Subject: Peace District Low Volume Roads

To clarify the Ministry's Policy with regard to the design of Low Volume Roads in the Peace District.

EARTH CUT SECTION

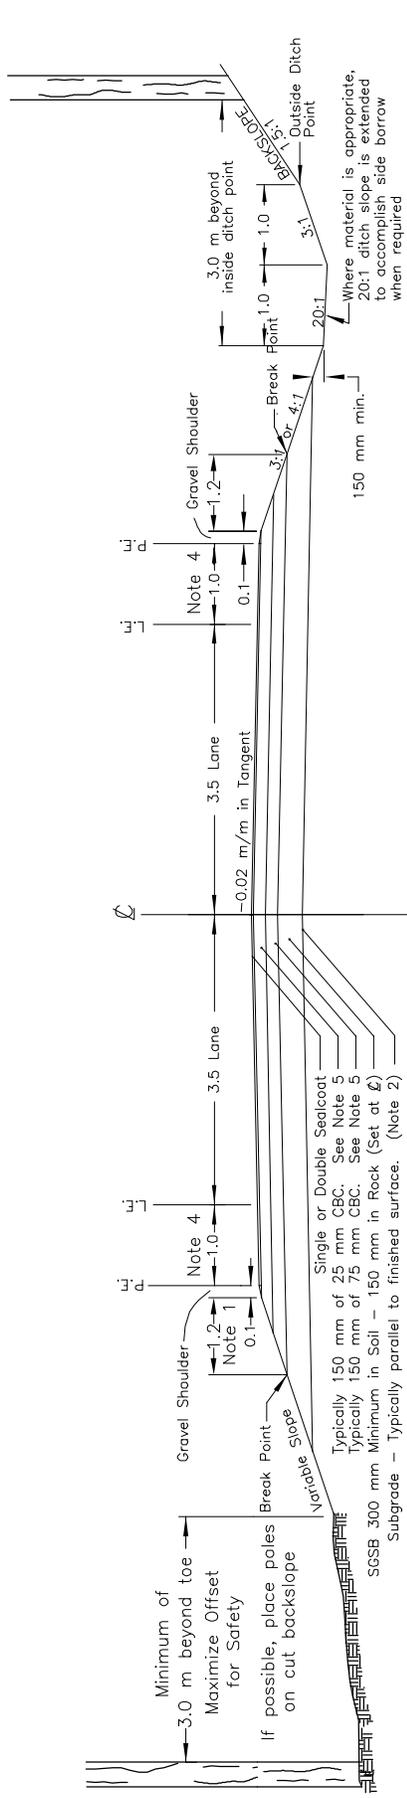
Recent discussions with stakeholder groups within the Peace District have highlighted concerns that the public has with our current approach to hard surfacing roads in the area. The current strategy of an 8.3 metre top with 1.5:1 shoulder slopes has raised two main concerns.

- The paved surface is too narrow to properly accommodate the large vehicles in use by agriculture and industry.
- The larger agricultural and industrial vehicles have difficulty using the shoulder slope, when and where necessary.

In order to address these concerns a decision has been taken to revise the current template on future construction, where economically feasible. The new template will incorporate a 9.0 metre hard surfaced top with 3 or 4 to 1 shoulder slopes. (See typical section attached)

The use of the revised template, as a minimum standard for low volume roads, is a requirement for all projects within the Peace District effective immediately. Exceptions to this standard will only be considered, as outlined in the previous section, after stakeholder consultation and review of appropriate road template standards to be applied for the given road. At a minimum, stakeholder consultations will include MLAs, the Regional Transportation Advisory Committee, and Rural Roads Task Forces.
